FORM APPROVED
OMB NO. 1004-0135
Expires: July 31, 2010**SUNDRY NOTICES AND REPORTS ON WELLS**
*Do not use this form for proposals to drill or to re-enter an abandoned well. Use form 3160-3 (APD) for such proposals.*5. Lease Serial No.
NMLC029435A

SUBMIT IN TRIPLICATE - Other instructions on reverse side.8. Well Name and No.
RAVEN FEDERAL COM 22H9. API Well No.
30-015-43361-00-X110. Field and Pool, or Exploratory
CEDAR LAKE11. County or Parish, and State
EDDY COUNTY, NM

Apache request change in Surface Use Plan - Proposed production facilities:

EXHIBIT 1A

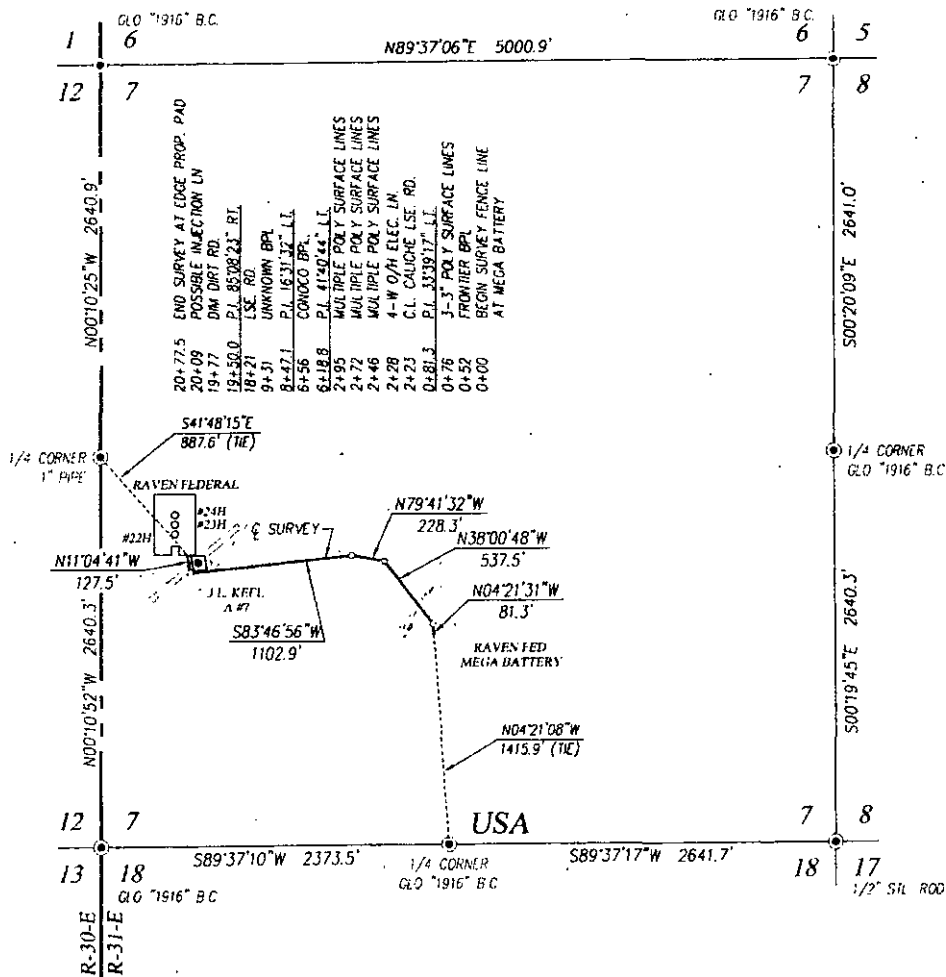
OLD: 6" buried Steel, 740psi, 2078' pipeline from proposed well to offsite facility at the Raven Federal Mega Battery. 30' work area needed to install pipeline.

NEW: 3" buried, 3.53 OD, 2.96 ID, 750psi Fiberspar flowline approx 2078' in length following same path as on approved APD (Exhibit 1A attached). A 50' wide work area will be needed to install pipeline.
